Business and Public Consultation Group Meeting

Chapel Hill Park and Ride – Alternate Site

Environmental Assessment

Date/Time: November 18, 2015 / 6:30 PM

SHARED NAVAN ACCESS
BUS LANE FROM PAGÉ

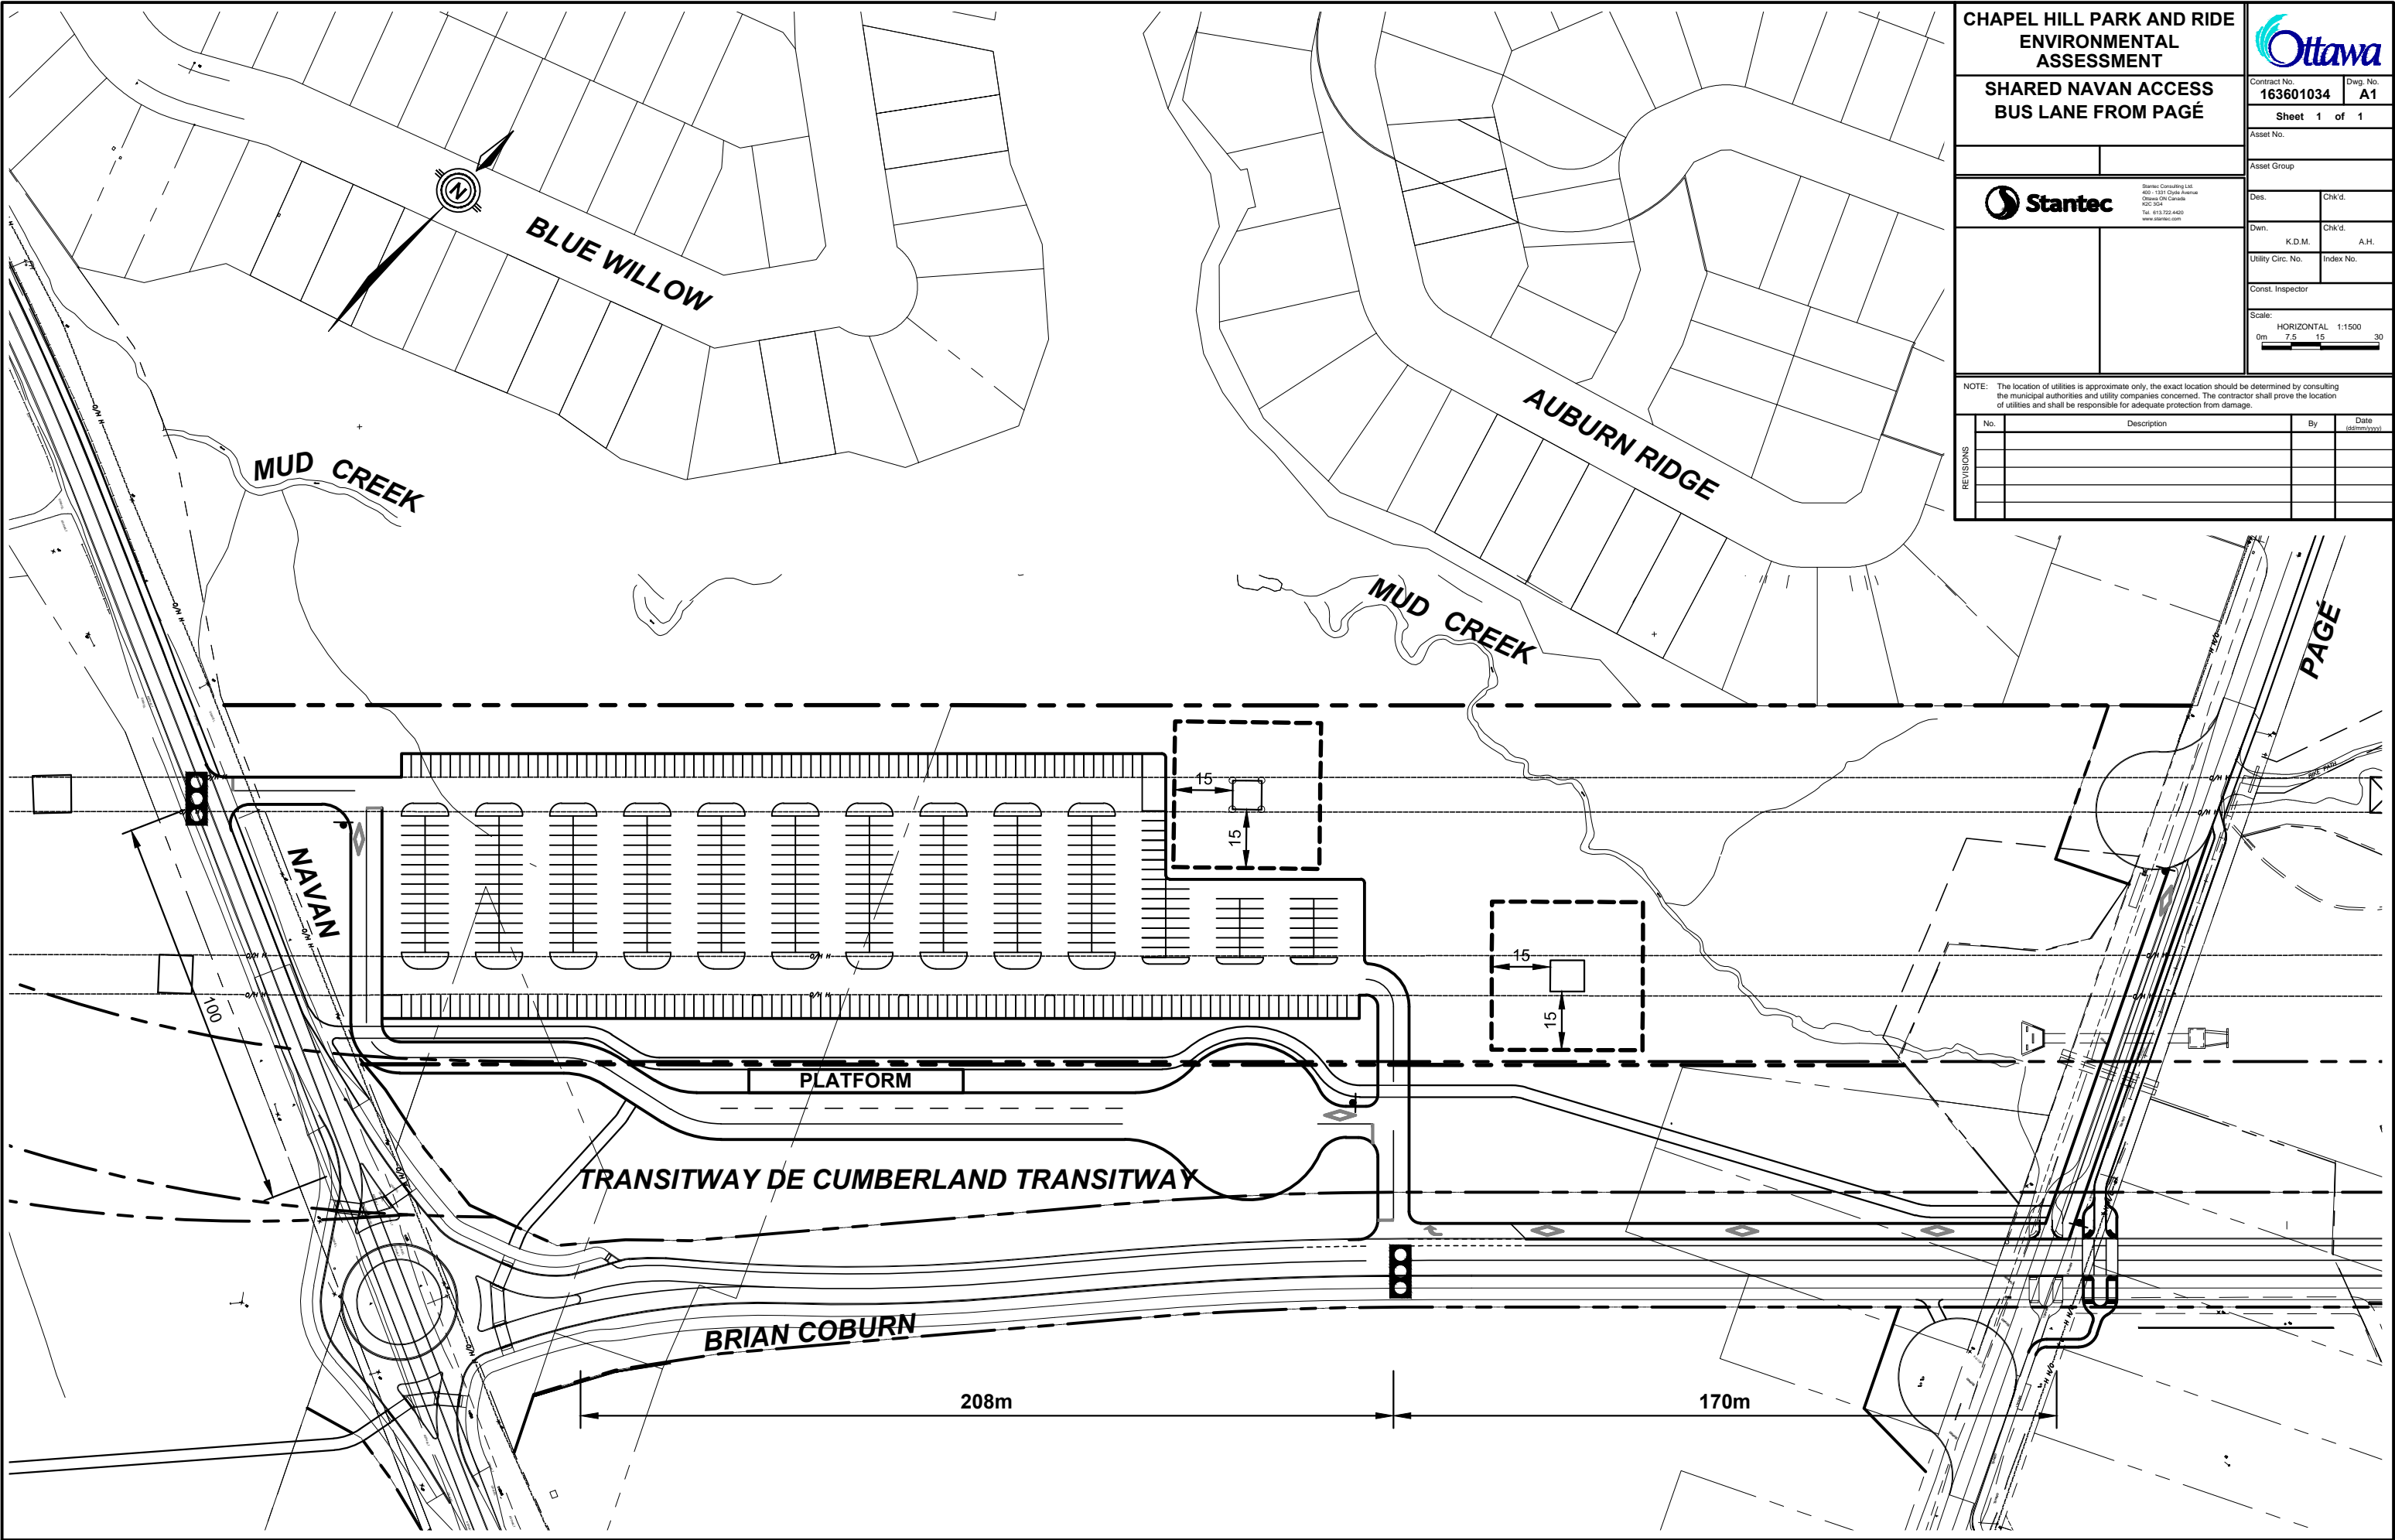
F. Perrault-Leblanc inquired as to the number of parking stalls shown in Alternative A1. R. Vastag noted it was in the range of 530 stalls, less than the other alternatives. F. McKinney noted that it is anticipated that it will only be built out to half of that by 2031.

ROUNDBOUT ACCESS
NO BUS LANE FROM PAGÉ

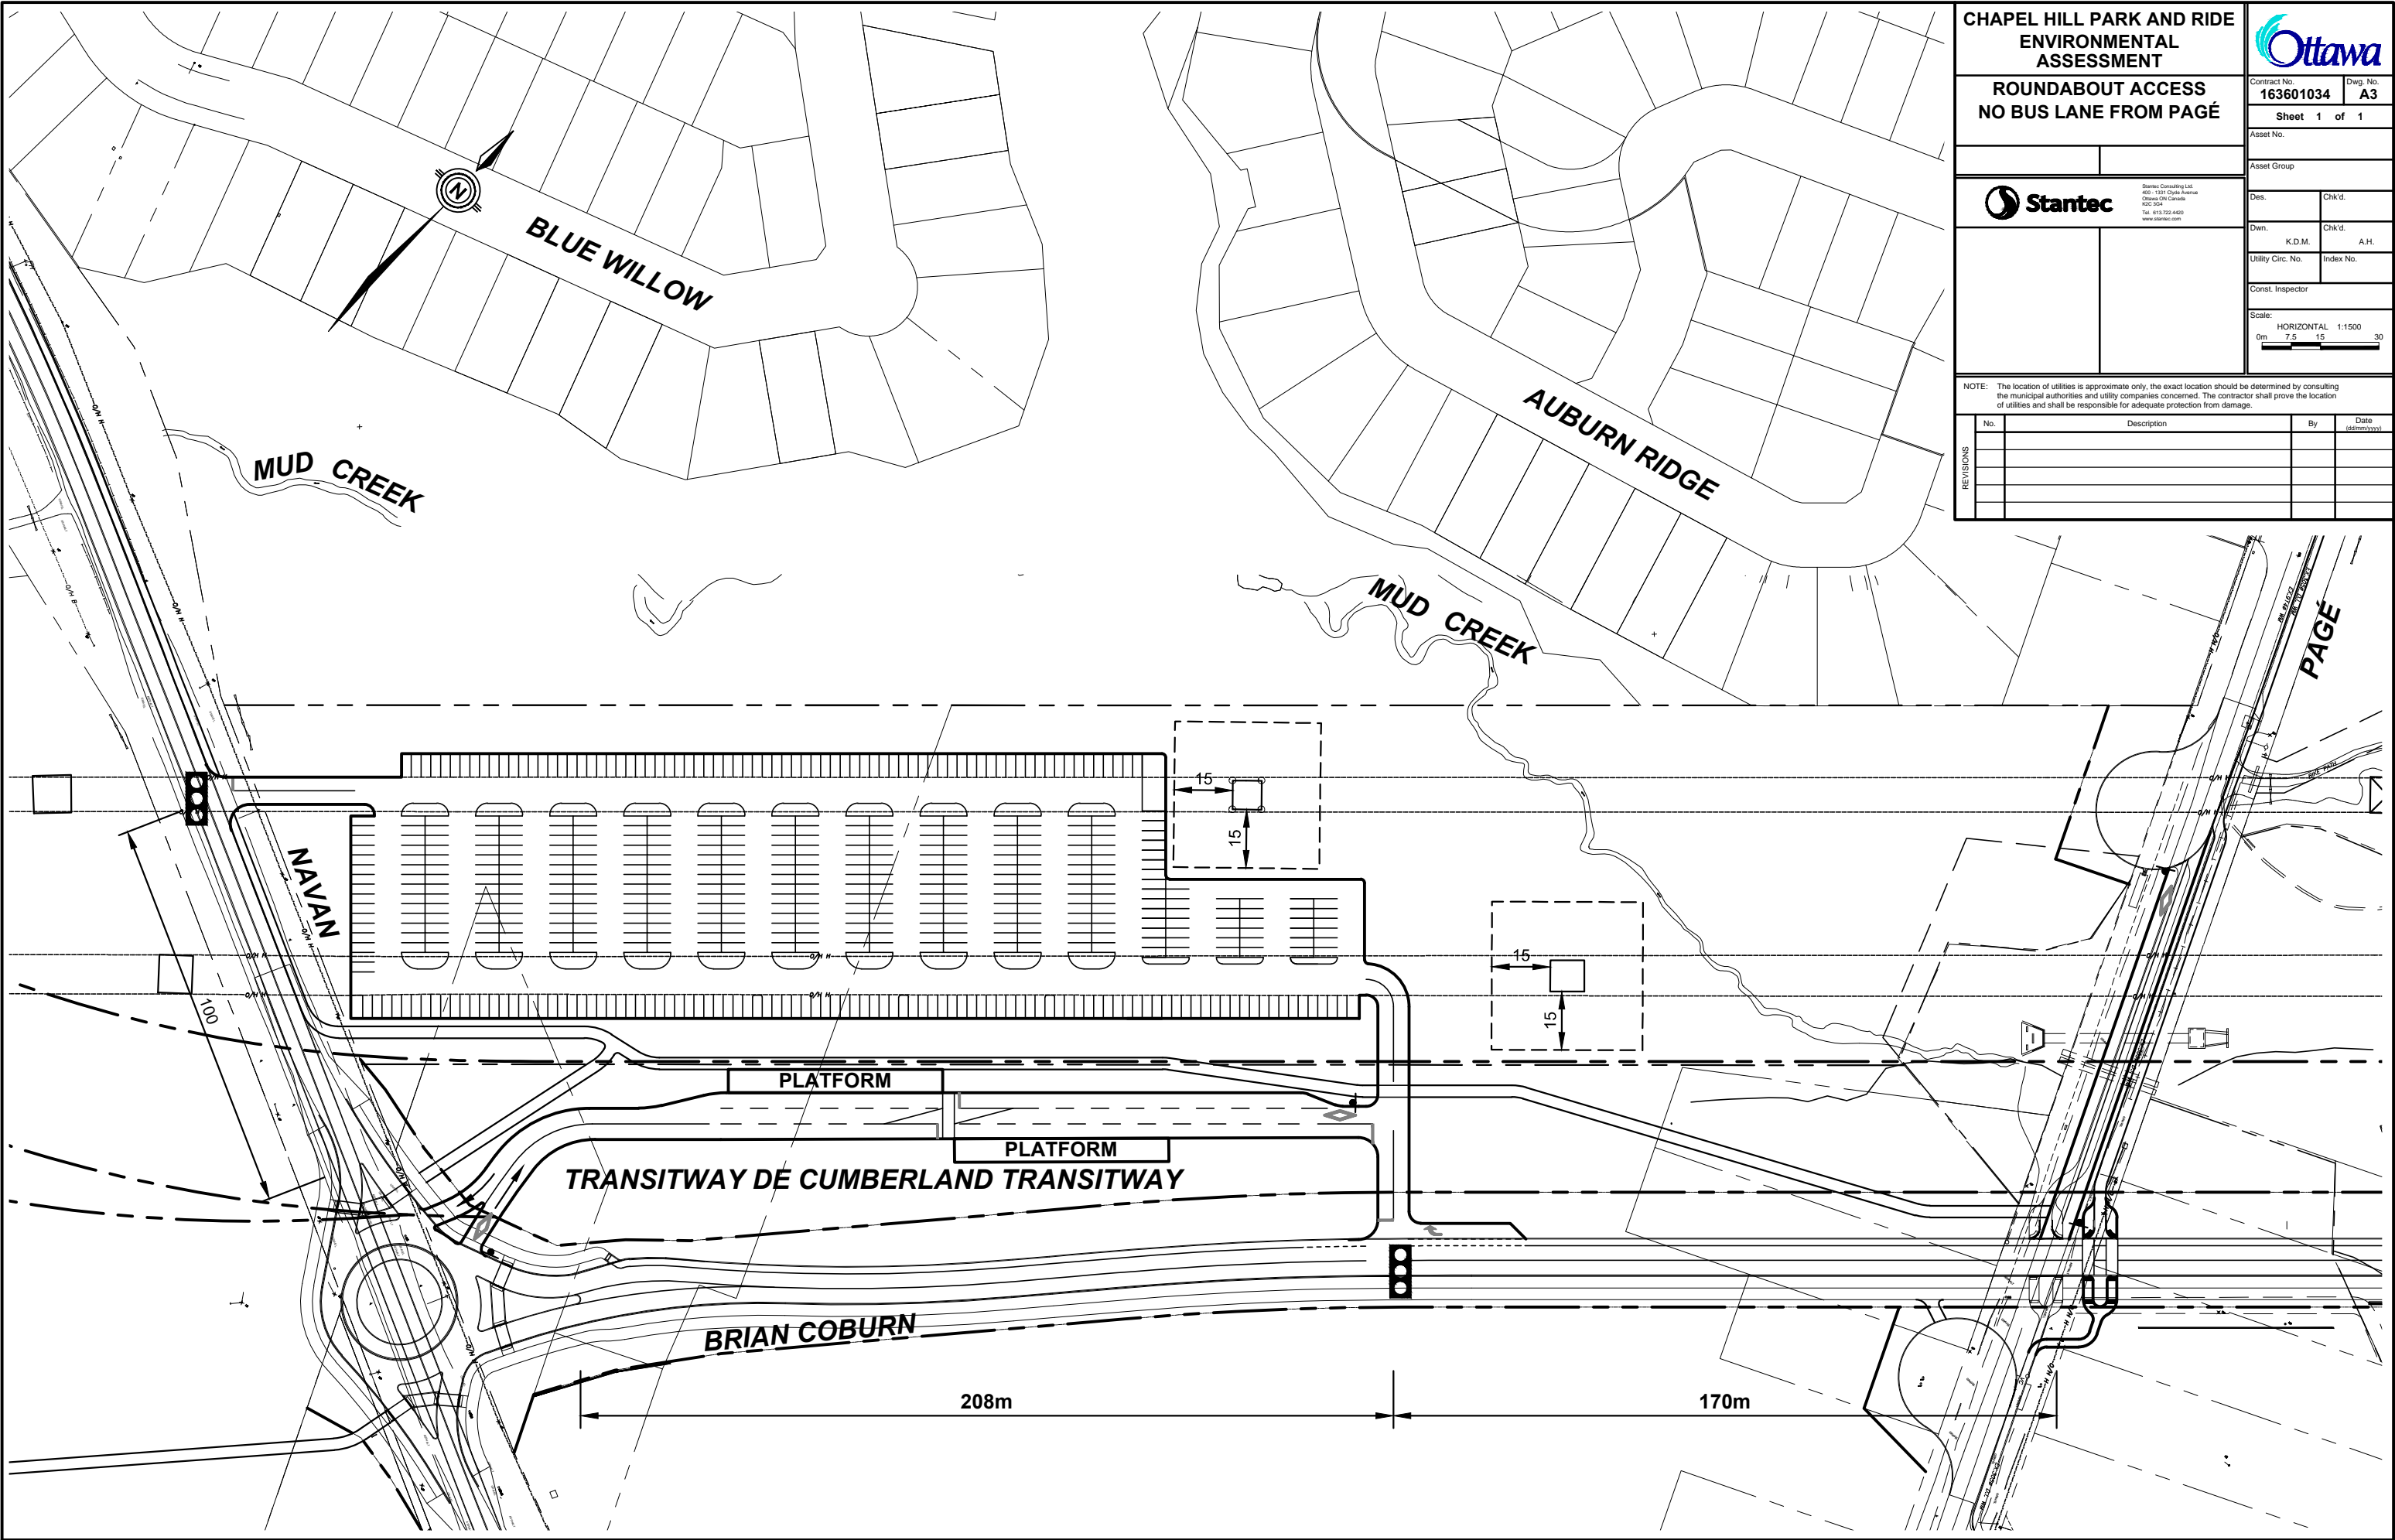
J. Black inquired about the need for 2 platforms in the preferred plan. R. Vastag noted that this eliminated the need for the bus turnaround within the Park and Ride and could accommodate bus routing.

Y. Fathers requested an additional pedestrian connection from Brian Coburn Boulevard to the south platform, either mid-block or from the access intersection. R. Vastag confirmed that this will be included in the functional design.

- Natural, Cultural, Social and Economic environments and Constructability equal between all alternatives
- Alternative A3 utilizes the roundabout at Brian Coburn Boulevard and Navan Road to provide transit access to the P&R in lieu of Navan Road
- Access from roundabout and south side platform eliminates the need for bus turnaround
- Access configuration of Alternative A3 was preferred from a transit perspective

Carry forward [Alternative A3](#) and refine access configuration through further consultation and functional design
